UNITED STATES PATENT AND TRADEMARK OFFICE

| APPLICATION NO. | FILING DATE | FIRST NAMED INVENTOR | ATTORNEY DOCKET NO. | CONFIRMATION NO. |
|--|-------------|----------------------|---------------------|------------------|
| 10/617,088 | 07/11/2003 | Paul S. Mosher | 23148 | 3349 |

DETAILED ACTION***Claim Rejections - 35 USC § 102***

Back view of Fig. 1. The crank and the spring in Forman is superimposed onto Fig. 1 in Arkell.

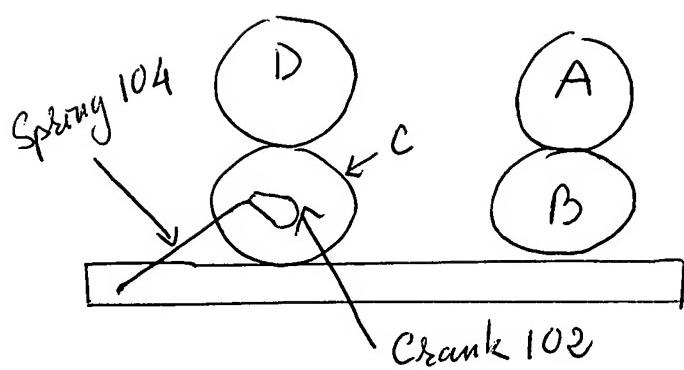
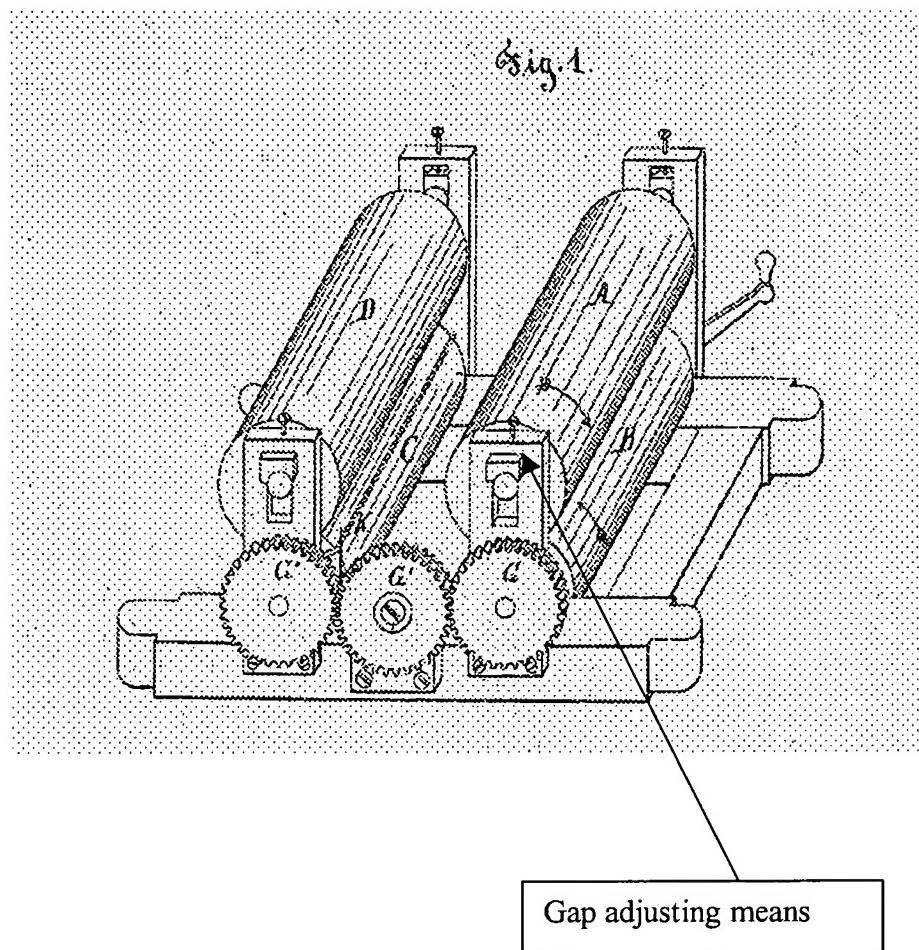
Regarding claim 1, Arkell teaches all the recited elements of the invention including a frame, a pinch wheel pair (A and B), a cutter wheel (C) having a blade (K) and an anvil (D). See Figs. 1 and 2.

Means (A and B) for feeding the strip of material along the feeding axis.

The friction created by the strip of material, the cutting wheel (C) and the anvil (D) and the forward movement of the strip of material created by rollers (A and B) cause the rotation of the cutting wheel (C) against the anvil (D) for severing the strip of material.

The anvil (D) and the cutting wheel (C) advance the cut strip of material.

Regarding claims 6 and 9, gears (G, G' and G'') turn the pinch wheel pair, the cutter wheel and the anvil in unison. See Fig. 1.

Regarding claim 10, means for adjusting a gap between the pinch wheel pair is best seen in Fig. 1.
